RE: GWF Tracy (08-AFC-07C) Proposed Minor Project Modifications

**Request for Approval of Minor
Project Modifications
for the
GWF Tracy Combined Cycle
Power Plant
(08-AFC-07C)**

October 2011

FIGURE 1
PROPOSED TRACY HILLS
LANDSCAPING PLANTINGS
 GWF TRACY COMBINED POWER PLANT PROJECT
 SAN JOAQUIN COUNTY, CALIFORNIA

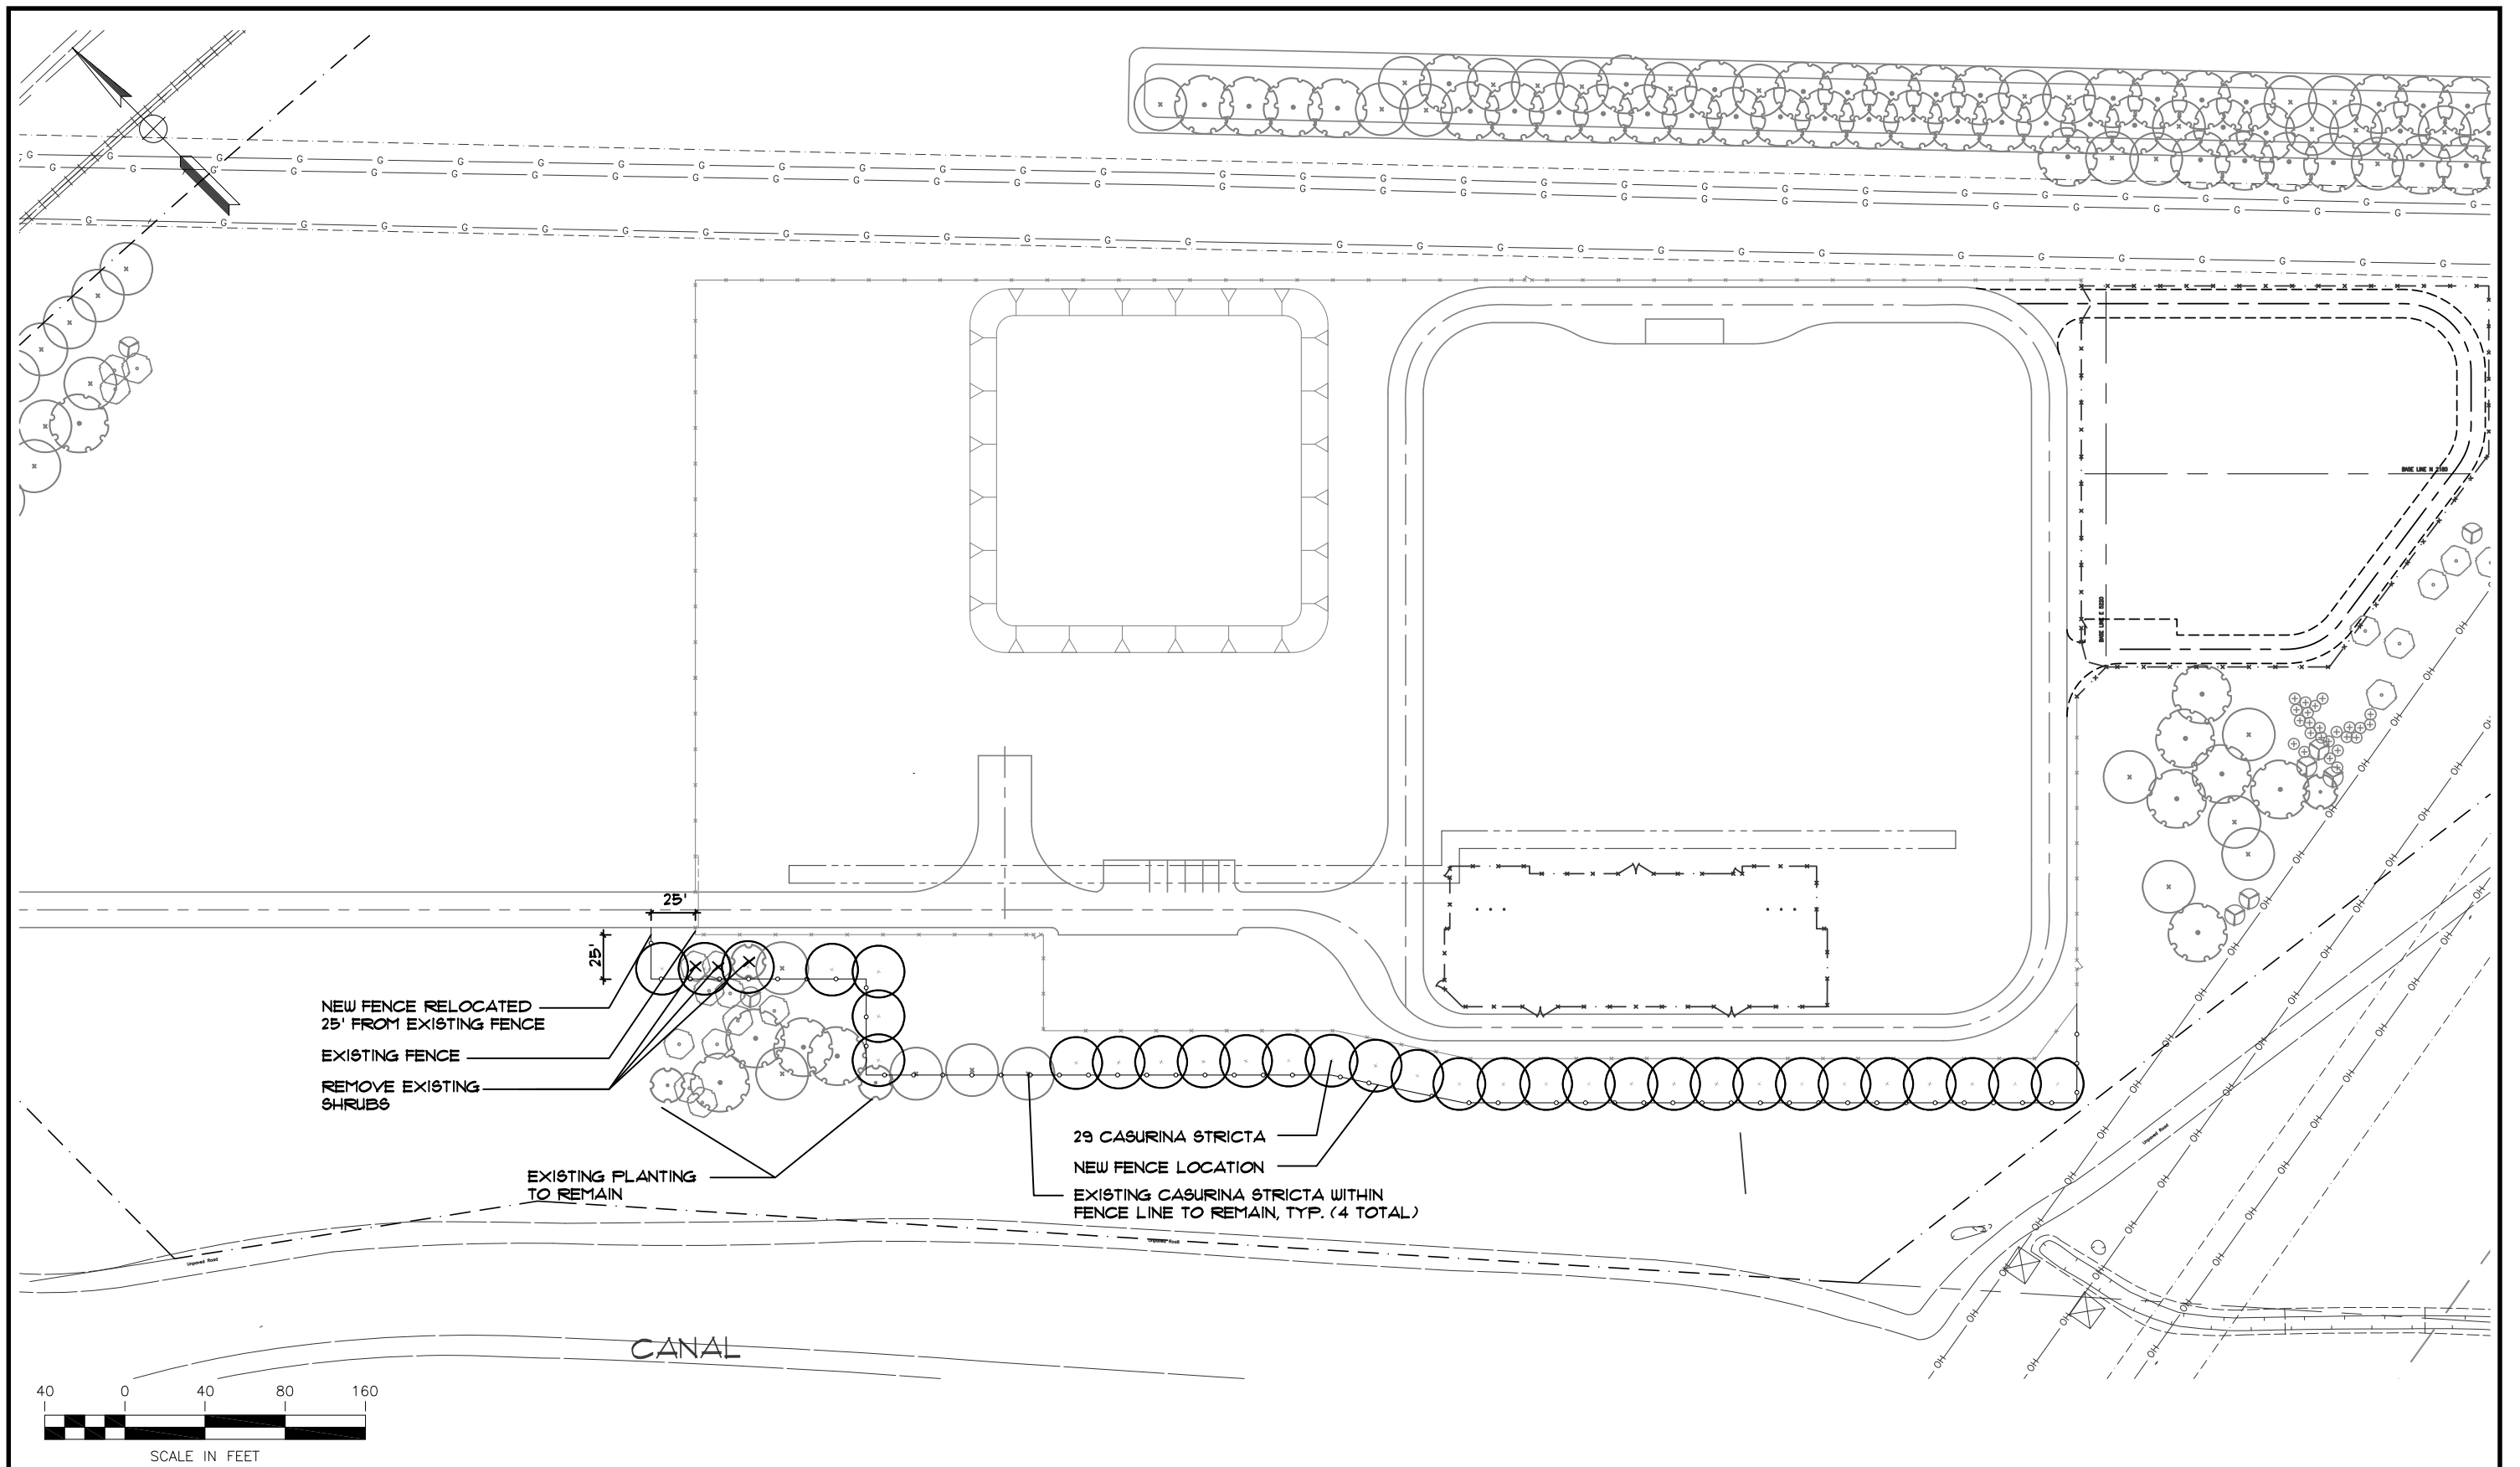
The final project design change is to incorporate landscaping along the southwestern project fence line within the area between the plant and the Delta-Mendota canal. The purpose of this landscaping is to effectuate an agreement with AKT LLC, the developer of the Tracy Hills project. The landscape mitigation includes the planting of Lombardi Poplar or Italian Cypress within the Delta-Mendota Canal buffer to provide a viewshed buffer for the Tracy Hills planned development, which is located south of GWF Tracy. Figure 1 presents the proposed landscaping plan. Section 3.3 presents a discussion of the potential biological resource impacts associated with this proposed change.

GWF has negotiated an agreement with the developer of the Tracy Hills project to install landscape screening on the southwestern boundary of the project, within the Delta-Mendota Canal buffer. The Final Decision (COC BIO-7) states that any landscaping within the Delta-Mendota Canal buffer will require approval by U.S. Fish and Wildlife Service (USFWS) and California Department of Fish and Game (CDFG) because this buffer area provides a critical SJKF migration corridor. GWF has met with representatives of the SJCOG, the USFWS, and CDFG to discuss the need for this landscaping and its potential impacts to the SJKF.¹ During this meeting, agency representatives determined that the plantings were appropriate for screening and that the addition of Lombardy Poplars or Italian Cypress would be acceptable. Therefore, the proposed changes do not require a modification to the COCs or mitigation requirements. This change will not result in an increase in biological resource impacts beyond those analyzed in the Final Decision or the FDOC.
